RGR Sweater Ltd (Extention-02)

Madhokala, Sreepur, Gazipur 1740

17 April 2025

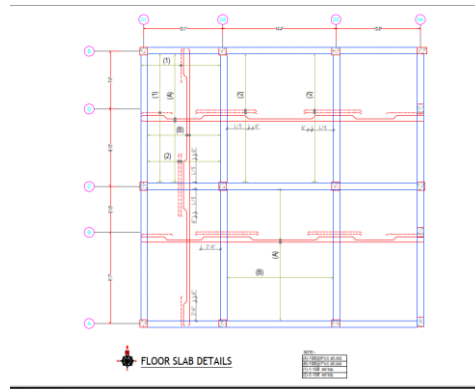
Observation 01: Lack of information in drawings. (Yarn Distribution Counter part-1,)

Description: Slab thickness was not found in the provided as-built drawings. Building engineer is required to revise the drawings with complete structural details and submit to RSC.

Observation 02: Trolley impact on columns. (Yarn Distribution Counter part-1, 2)

Description: Column surfaces were damaged due to trolley movement. Building engineer is required to provide guard to protect columns from trolley impact.

Observation 03: Improper connection of truss. (Canopy-1)

Description: Improper connection between truss and steel column was found. Building engineer is required to check the connection adequacy as part of a safety check report and submit to RSC.

Observation 07: Improper connection between angle and pipe column. (Wastage Store Shed)

Description: Improper connection between angle and pipe column was found in several locations. Building engineer is required to check the connection adequacy as part of safety check report and submit to RSC.

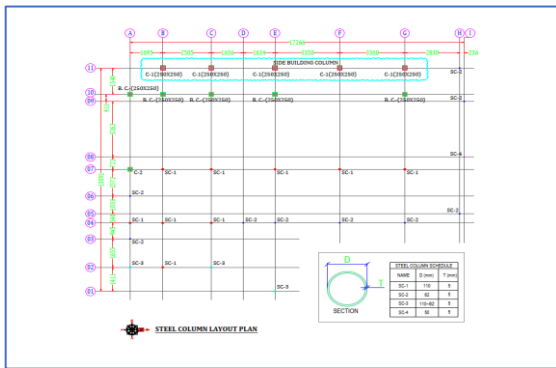
Observation 08: Incomplete as-built drawings. (Staff/Workers dining & kitchen Shed)

Description: Full area of the shed was not covered in the structural drawings. Also, connection details were not found in drawings. The building engineer is required to revise the as-built drawings and submit to RSC.

Observation 09: Improper connection between truss and pipe column (Staff/Workers dining & kitchen Shed)

Description: Improper connection between angle and pipe column was found in several locations. Building engineer is required to check the connection adequacy as part of engineering assessment and submit to RSC.

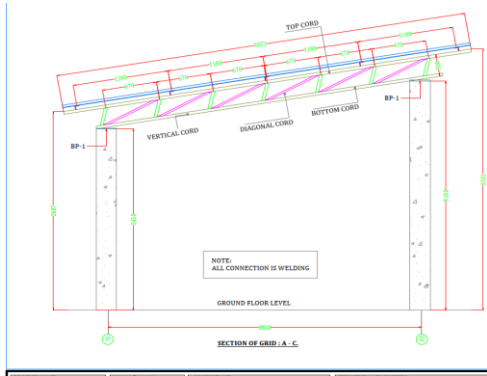
Observation 10: Mismatch in as-built drawings. (Fire pump room)

Description: All sectional and connection details were not found in drawings. The building engineer is required to revise the as-built drawings and submit to RSC.

Observation 11: Improper connection between truss and RC column. (Fire Pump Room)

Description: Improper connection between angle and pipe column was found in several locations. Building engineer is required to check the connection adequacy as part of safety check report and submit to RSC.

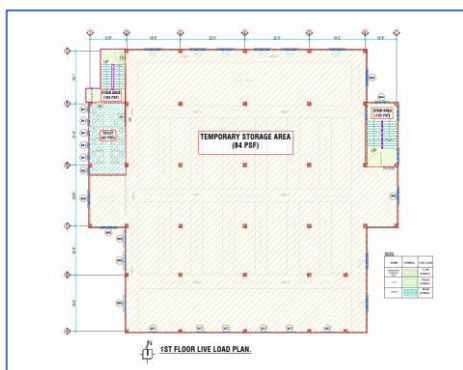
Observation 12: Load plan and design report does not comply with BNBC. (Linking Building)

Description: In storage areas floor loading was consider 84 psf which is not comply with BNBC 2020. Also, concrete material strength was considered 3500 psi but sufficient test report was not found. Building engineer is required to update the floor load plan along with design report and submit to RSC.

Observation 13: Lack of drawings for adjacent Steel stair and Fire Control Room. (Linking Building)

Description: As-built drawings were not found for adjacent external steel stair and Fire Control Room. The building engineer is required to prepare a full set of as-built drawings and submit to RSC.

Observation 14: Water clogging on roof. (Linking Building)

Description: Stagnant water on the roof was found during the inspection. The roof was constructed by MCAC. Building engineer is required to provide water proofing layers and improve drainage system.

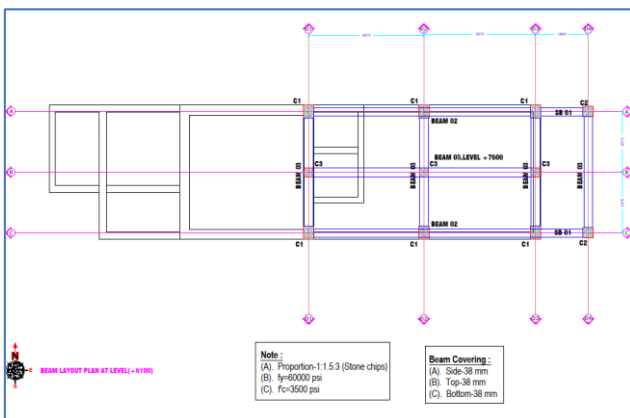
Observation 15: Lack of information in as built drawings. (ETP Building)

Description: Beam layout do not fully match with the as-built conditions. Also, no details were found for the steel portion stair. The building engineer is required to prepare a full set of as-built drawings and submit to RSC.

Observation 16: Lack of design report. (ETP Building)

Description: As per BNBC, every building or structure designed shall have its design documents prepared following the provision of Section 1.9.1. The design document shall include a design report and a structural drawing. At the time of inspection, no design reports were available which are required to be prepared in compliance with section 1.9.1.1 and section 1.9.1.2 (part 6, BNBC).
